ENGINE - MAIN GEARBOX ASSEMBLY - INCORPORATE A PMA DRIVE GEAR ASSEMBLY WITH DECREASED
PINION TOOTH THICKNESS - CATEGORY CODE 4 - MOD.ENG-72-0048

PMA drive gear assembly wear caused by loss of teeth clearance in operation can occur. To eliminate this problem the backlash is to be increased by reducing the tooth thickness of the gear, the existing oil nozzle is to be revised and a target hole added.

V2500-ENG-72-0048

Removal and Installation of the PMA Drive Housing
Fig.5

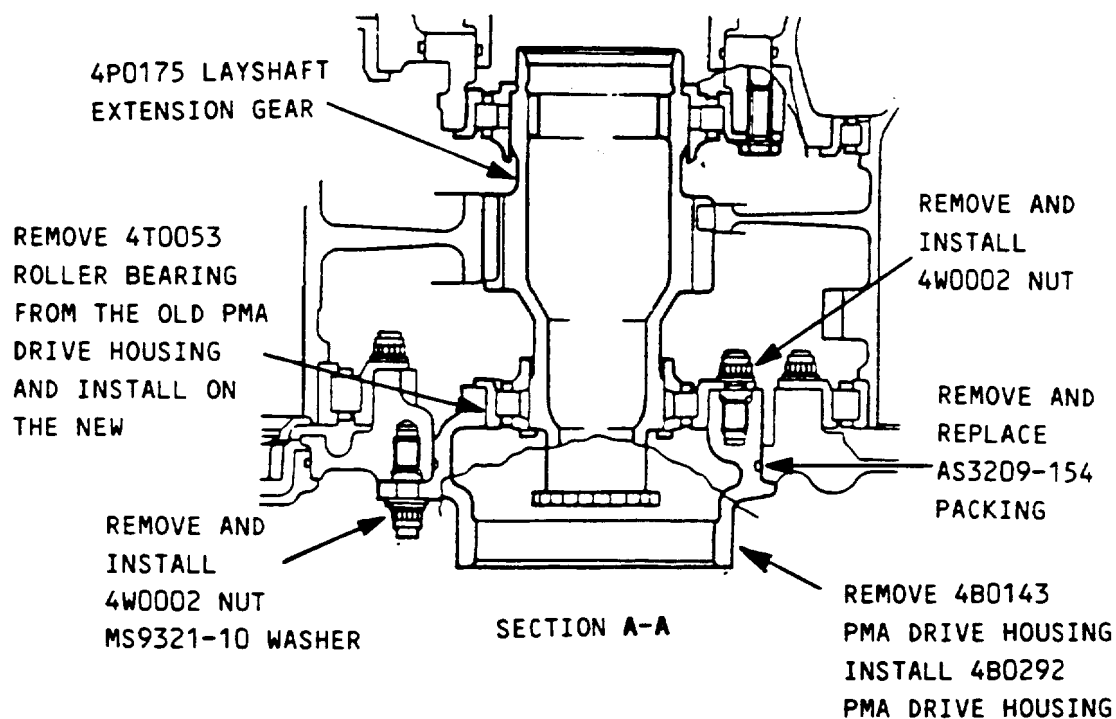
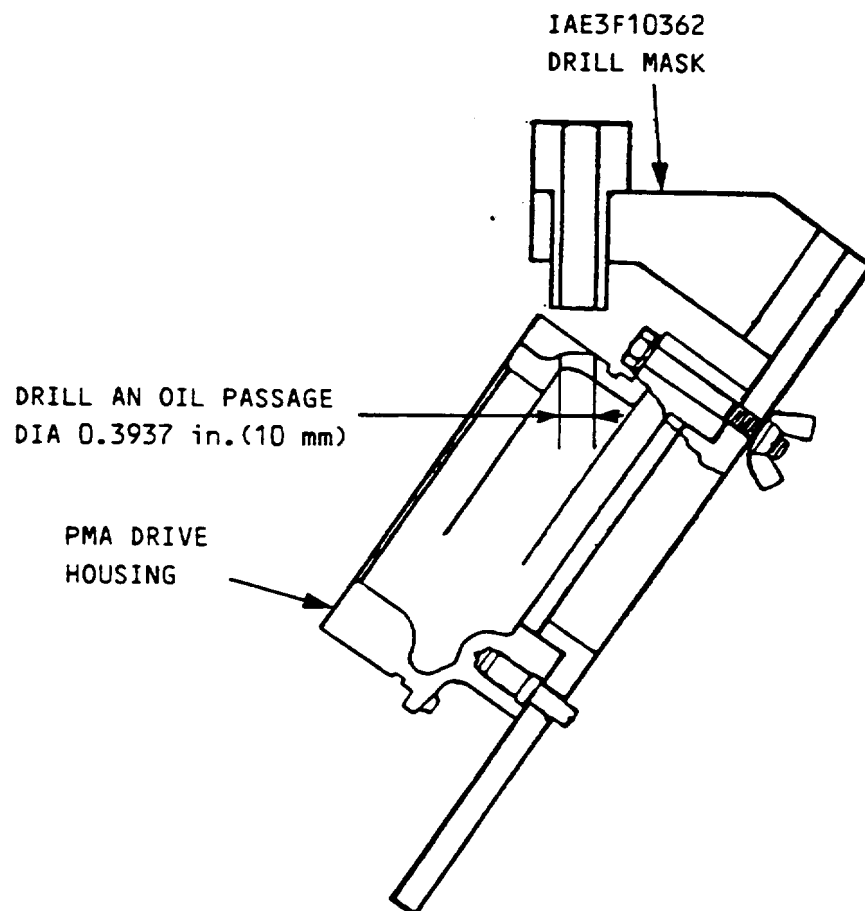
- (v) Remove and discard the two AS3209-151 and AS3209-114 packings from the PMA drive gear assembly.
- (i) Remove the 4B0143 PMA drive housing assembly. Ref Figure 5.

- (i) Remove the two 4W0002 nuts and MS9321-10 washers which attach the housing to the gearbox.
- NOTE: Hold the layshaft extension gear in position during the removal of the housing.

- (ii) Remove the old 4B0143 PMA drive housing assembly with the outer race of the roller bearing from the gearbox.
- (iii) Remove and discard the AS3209-154 packing from the housing.

- (c) Safety the oil nozzle with CU37148 washer and 4W0002 nut. Torque to 85 to 95 lbfin. (0,96 to 1,07 mdaN).
- (2) Install the 4B0292 PMA drive housing. Ref Figure 5.

- (a) Install the 4T0053 roller bearing outer race on the new housing. Install the three 4W0002 nuts and torque to 85 to 95 lbfin (0,95 to 1.07 mdaN).
 - (b) Install the new AS3209-154 packing on the housing.

- (c) Make sure that the layshaft extension gear is correctly positioned in to the gearbox.
 - (d) Align the hole of the housing flange with the studs on the gearbox and the outer race with the inner race of the roller bearing installed on the gearshaft.

- (e) Put the housing over the gearshaft and install in the seat on the gearbox.
 - (f) Install the two MS9321-10 washers and 4W0002 nuts on the two shorter studs. Torque to 85 to 95 lbfin (0,96 to 1.07 mdaN).

- (g) Release again the two nuts. Torque these nuts only after the installation of the PMA drive gear assembly.

Drill an Oil Passage on the PMA Drive Housing
Fig.6

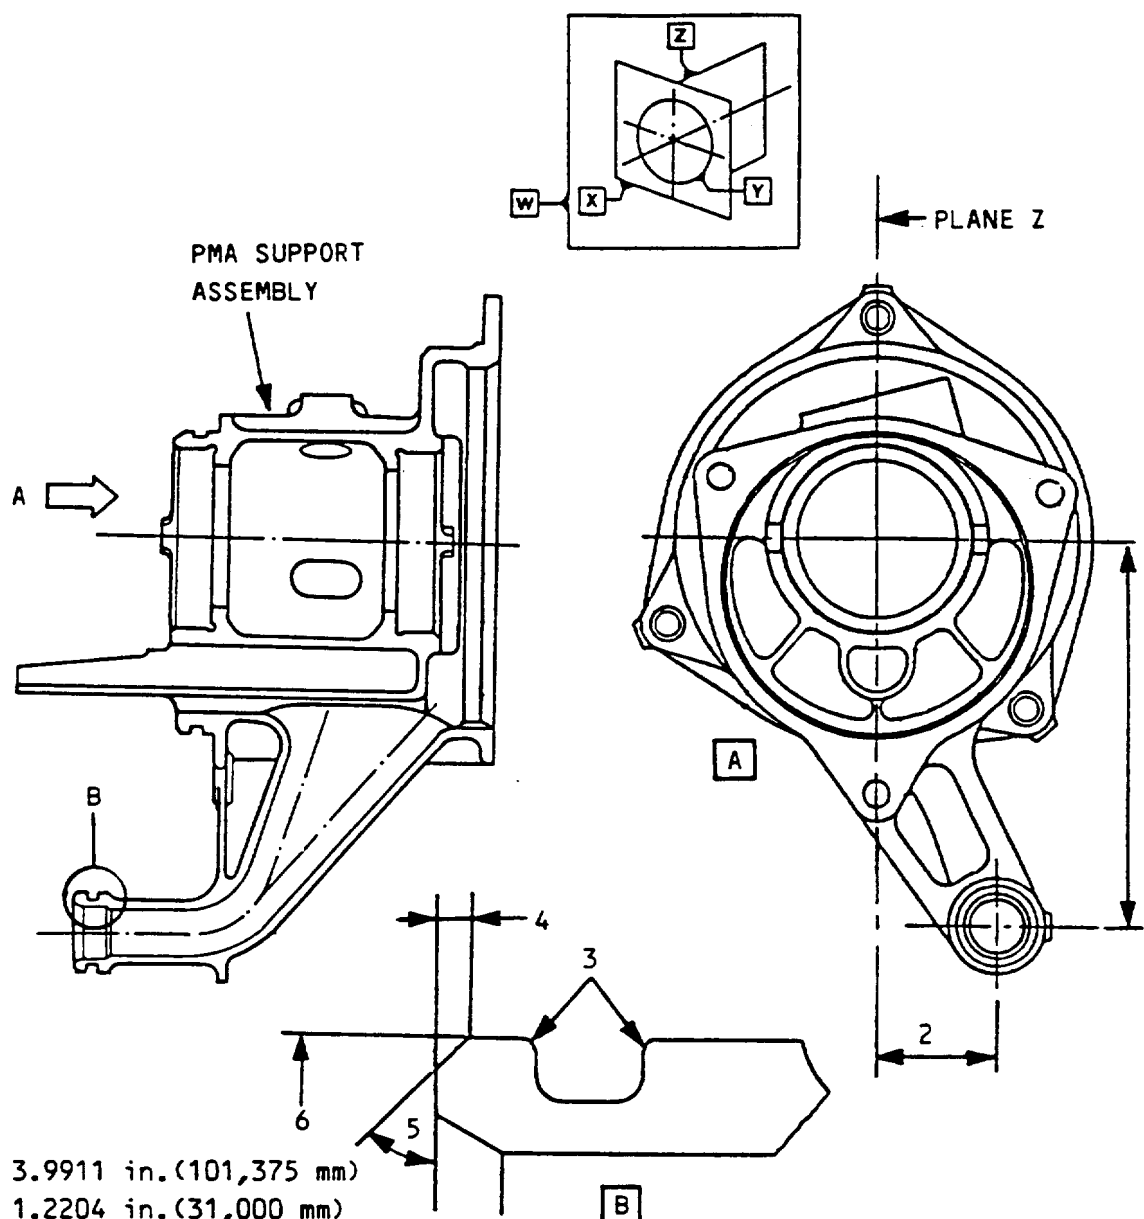
- (1) Drill an oil passage on 4B0143 PMA drive housing assembly.

Procedure	Supplementary Information
(a) Install the housing on IAE1F10362 drill mask and safety with the bolts and nut.	Refer to Figure 6.
(b) Attach the drill mask to a bench vise.	
(c) Drill an hole through the housing.	Use an electrical hand drill with a 0.3937 in. (10 mm) drill.

| (g) Renumber by the vibro-peen adjacent to the old part number on the housing. | Old P/N

4B0143 | New P/N
4B0292 |

Machine the Diameter of the PMA Support Assembly
Fig.7

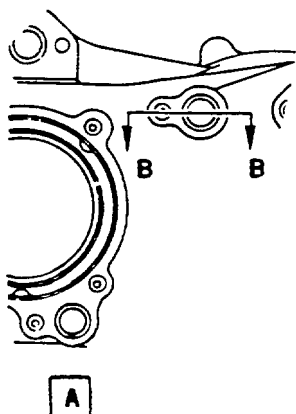
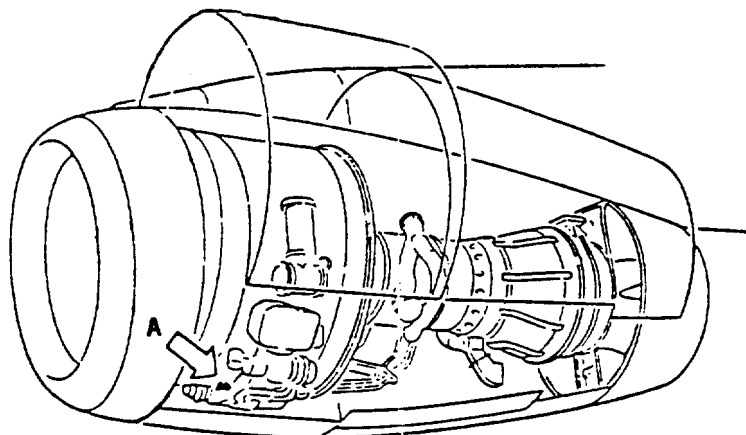
- (3) Reduce the diameter of the manifold of 4B0253 PMA support assembly.

| (a) Reduce the diameter of the support to obtain the dimension specified. | Refer to Figure 7.

Clean up edges of grooves and chamfers, where necessary. | |

| (b) Renumber by the vibro-peen adjacent to the existing part number. | Old P/N

4B0253 | New P/N
4B0289 |

Removal and Installation of the Oil Nozzle
Fig.8

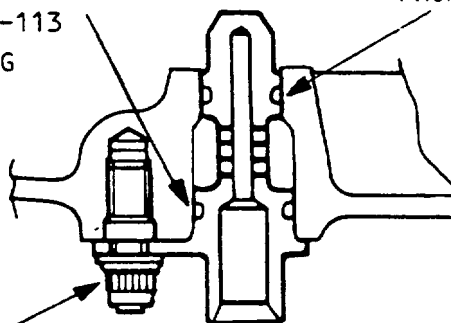
REMOVE
4P0240 OIL NOZZLE
INSTALL
4P0291 OIL NOZZLE

- (1) Install the new 4P0291 oil nozzle on the gearbox. Ref Figure 8.
- (a) Install the new AS3209-113 and AS3209-110 packings on the oil nozzle.
 - (b) Install the 4P0291 oil nozzle on the seat near the PMA pad on the gearbox. Align the hole in the nozzle flange with the adjacent stud.
